SIMTA Intermodal Terminal Project – Stage 1

Peer Review of the Environmental Impact Statement

Project Number: 8201511201-01/Report 001 Ver 2

Prepared for
Liverpool City Council

FIGURE 2-2

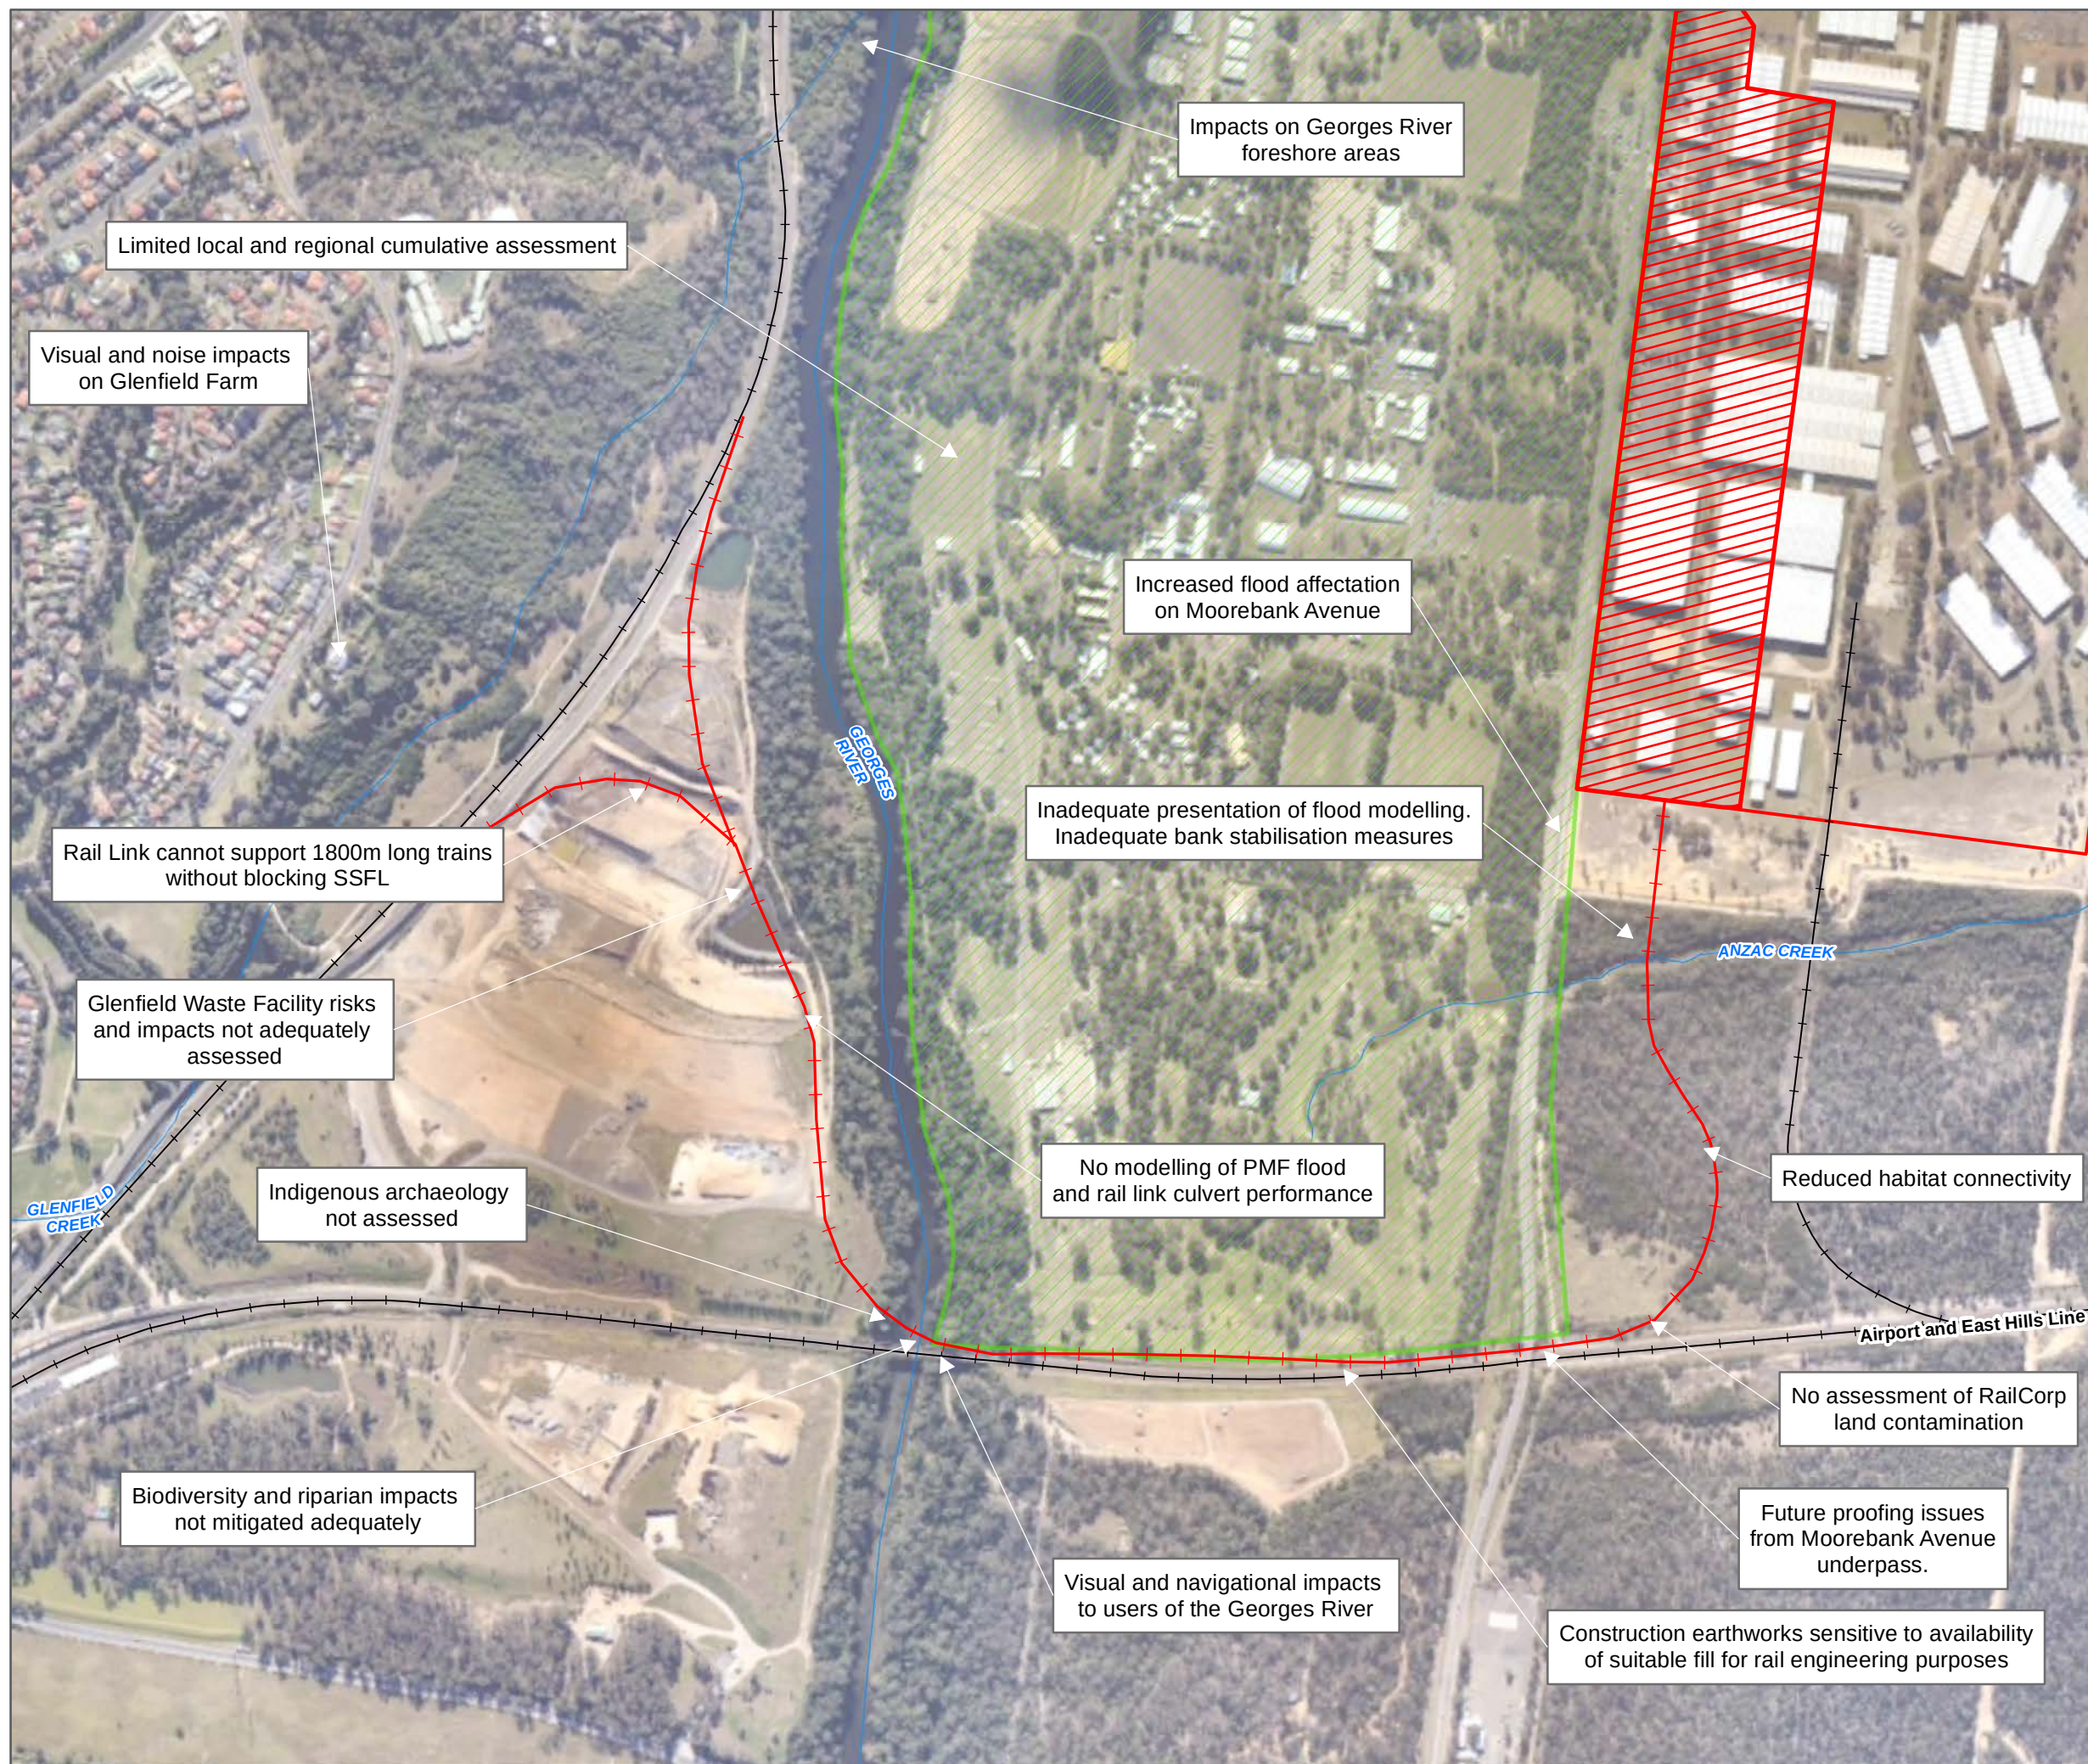
The assessment of the proposed rail link has resulted in a number of issues being identified. These issues cover a number of disciplines with additional assessment, additional information and potential rail alignment re-design necessary prior to any determination of the application. These issues include:

- > Rail geometry – a number of non-compliances with ARTC standards have been identified throughout Cardno's assessment. Specifically, the design of the rail loop appears to be mainly focused on the northern entry and 650m long trains. This does not correlate with the ARTC's request for the rail link to be able to accommodate 1800m long trains. In particular, the clear distance from the southern SSFL loop to the first cross over is insufficient to hold a 650m long train and the clear distance from the northern SSFL loop to the second cross over is insufficient to hold a 1800m train. This would result in standing trains located within the loop. Solutions to address this include moving the crossovers or the introduction of a parallel line. This is a key aspect that has not been considered and assessed.

- > Rail operation – the application has relied on assumptions from the Concept Plan (2013) regarding the IMT trip generation. It was assumed that there will be five trips to Port Botany and five trips from Port Botany spread evenly throughout the day. However, in reality this spread will be contingent on a number of external factors which have not been considered. Additional empirical evidence regarding the capacity of the SSFL is required to confirm the operational environment of the IMT, with negotiation and support from ARTC.

- > Land acquisition – a number of land parcels will require acquisition to facilitate the construction of the rail link. There has been no evidence presented in the application to provide certainty around the acquisition policy of SIMTA and the willingness of the landholder to allow SIMTA to construct and operate the rail link.

- > Construction impacts – inadequate information has been provided regarding the construction of the rail link and the volume of imported fill needed for the rail embankment. Construction of the rail link is likely to disturb an area greater than proposed cleared corridor, which will require additional information regarding re-vegetation, soil and water management and soil stabilisation to be provided. Furthermore, the Vegetation Management Plan (VMP) requires a limited level of information that would not result in protection of riparian vegetation and water quality of the Georges River during construction. The bulk earthworks strategy does not consider the required volume of imported fill needed for the rail embankment. The cost of importing this large amount of fill will be substantial which needs to be confirmed prior to the finalisation of the bulk earthworks strategy.

- > Visual impacts – limited assessment of the visual impact of the rail link along the western bank of the Georges River has been provided. The provision of the rail link along this alignment will fundamentally alter the vista from the Glenfield Farm heritage item, as well as the visual character of the Georges River for recreational users, with recreational use predicted to increase due to the planned upgrade of the Georges River Casula Parklands Precinct.

Figure 4-2 Cumulative Visual Impact, Casula Public Park

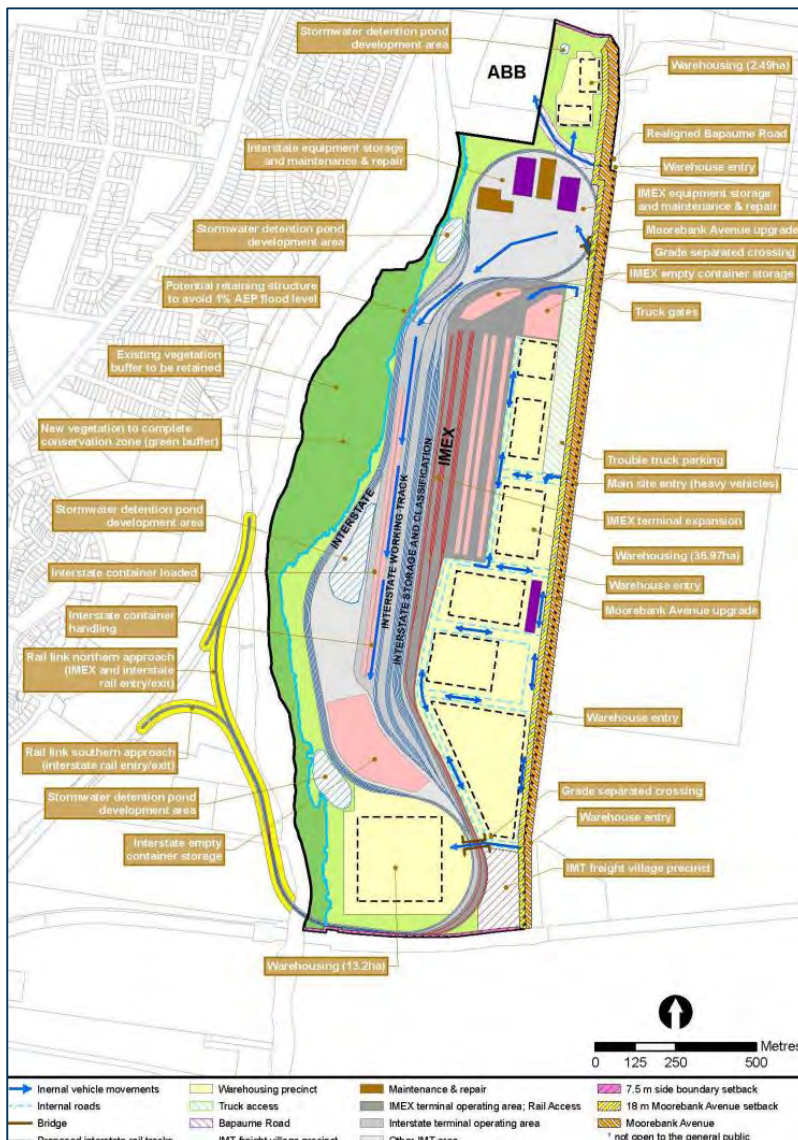
The assessment has concluded that cumulative impacts resulting from the construction of the MIC and SIMTA proposals would be significant to receivers adjacent to the MIC development and that its construction will provide a “visual shield” to the bulk of the SIMTA proposal. The Visual Impact Assessment conducted a cumulative impact assessment, however this was limited by its inability to provide appropriate building envelopes on site.

The assessment noted that it was limited by the extent of publicly available information associated with the MIC proposal. Consequently, the simulated visual impacts have been restricted to broad site boundary outlines, without any consideration of building envelopes and or tree removal (refer to **Figure 4-2**).

Figure 4-5 Location of Receivers with Viewpoint to Rail Link

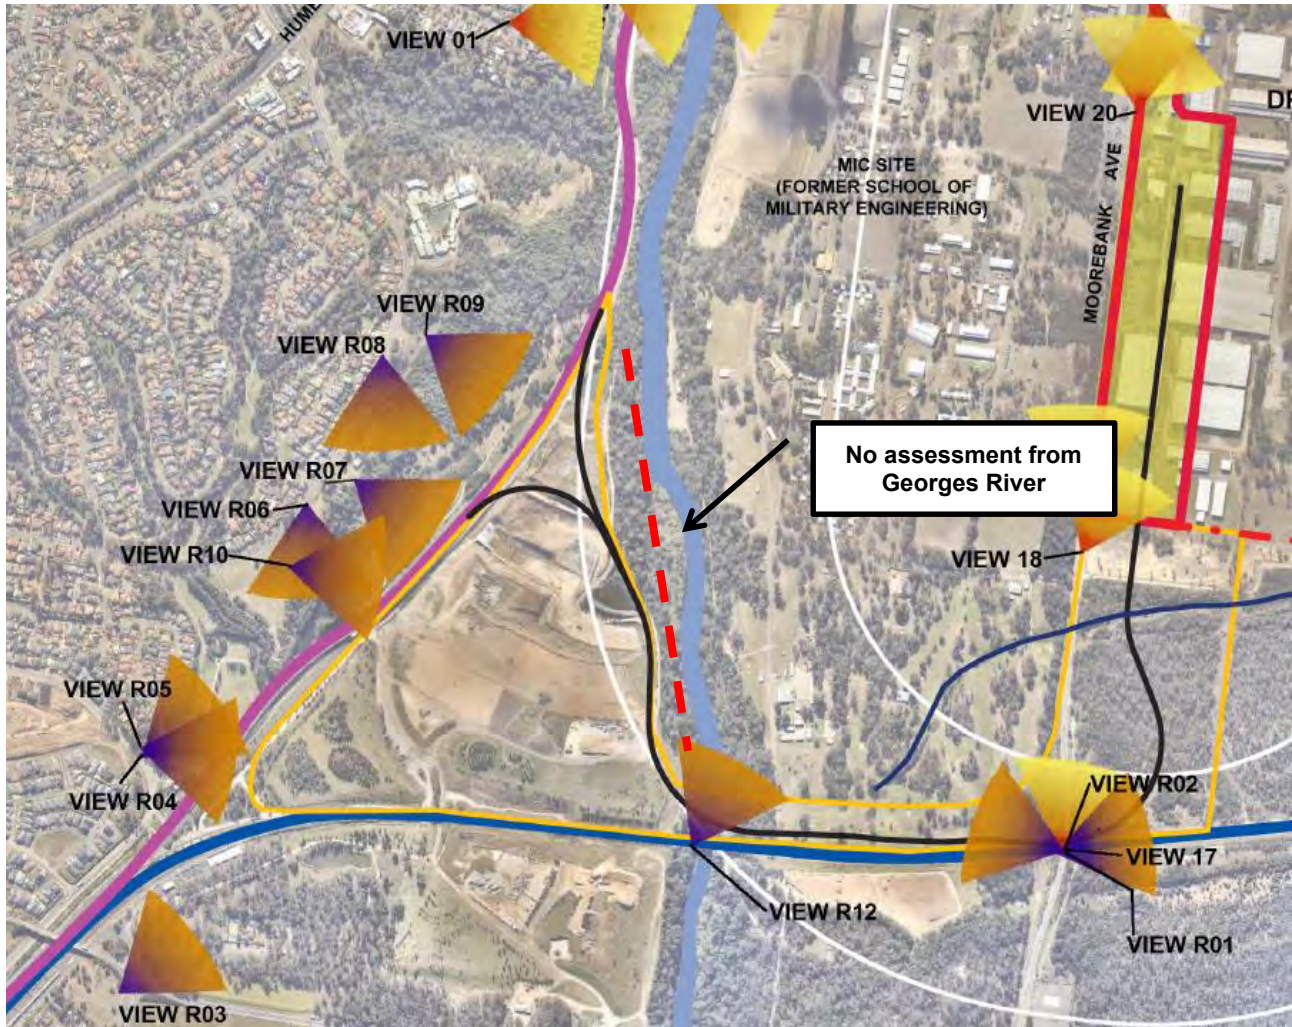
The visual impact assessment has not considered the visual impacts from the proposed rail link / rail corridor to a sufficient standard. The assessment has identified a number of sensitive receivers surrounding the rail link, however this has not considered users of the Georges River (refer to **Figure 4-5**).

Figure 4-6 Excerpt from the Georges River Casula Parklands Draft Master Plan

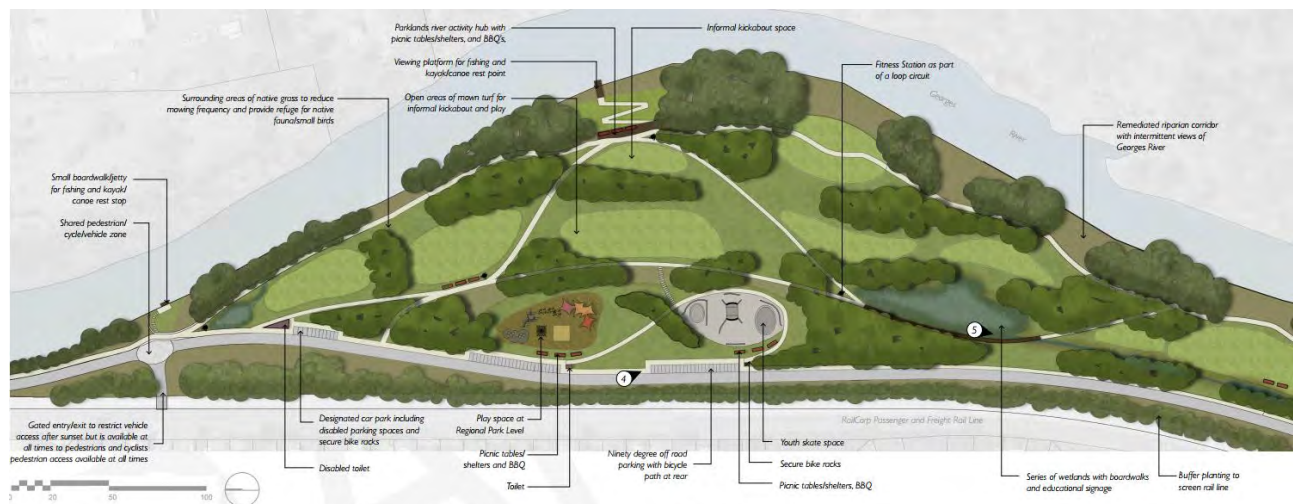
The Georges River is used by a number of recreational users throughout the year. This includes informal kayaking, canoeing and boating, along with a registered barefoot water-skiing club. The water-skiing club is located to the north of the M5 motorway, with its licence not extending to the section of the river located where the Rail Link occurs.

Despite this, the informal use of this area of the river is expected to increase into the future years. This is particularly likely due to the planned upgrade of the Georges River Casula Parklands surrounding the Casula Powerhouse Arts Centre. The Draft Master Plan for this area, particularly near the Powerhouse Arts Centre (refer to **Figure 4-6**), illustrates that a number of piers will be included to encourage recreational use of the river.
